Access Compliance Report

Public Rights-of-Way

Intersection ID: 50636	Main Street: BLUE_GROVE_RD	Cross Street: RED_WATER_RD	Location: NE
ADA ID: EA147BB73679	Ramp Type: Perp	Initial Pass/Fail: Fail	Overall Compliance: No
		Severity Score: 10

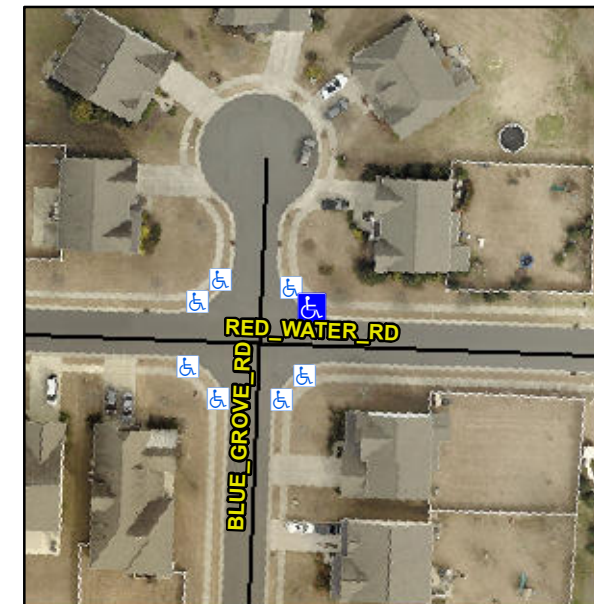
Not Found, R304.5.1, R304.5.3

Compliance	Description	Data	Compliance	Description	Data
N/A	Ramp Length (in)	48.0	Yes	Ramp Slope (%)	7.7
No	Ramp Width (in)	46.0	No	Ramp XSlope (%)	3.4
N/A	Flare Type LT	N/A	N/A	Flare Type RT	N/A
N/A	Flare Slope LT (%)	N/A	N/A	Flare Slope RT (%)	N/A
N/A	Flare Traversable LT?	N/A	N/A	Flare Traversable RT?	N/A
N/A	Landing Length (in)	N/A	N/A	DWS Provided?	N/A
N/A	Landing Width (in)	N/A	N/A	DWS Contrast?	N/A
N/A	Landing Slope (%)	N/A	N/A	DWS Length (in)	N/A
N/A	Landing X Slope (%)	N/A	N/A	DWS Full Width?	N/A
N/A	Landing Curb? (Y/N)	N/A	N/A	DWS Offset (in)	N/A
N/A	Shared Landing?	N/A			
N/A	Gutter Ponding?	N/A	N/A	Gutter Slope (%)	N/A
N/A	Gutter Lip Ht (in)	N/A	N/A	Gutter X Slope (%)	N/A
N/A	Painted X Walk1?	No	N/A	Painted X Walk2?	N/A
	X Walk 1 Direction	To SW		X Walk 2 Direction	N/A
N/A	X Walk 1 Width (in)	N/A	N/A	X Walk 2 Width (in)	N/A
	X Walk 1 Slope (%)	0.6		X Walk 2 Slope (%)	N/A
	X Walk 1 X Slope (%)	2.7		X Walk 2 X Slope (%)	N/A

Remove & Replace Entire Ramp.
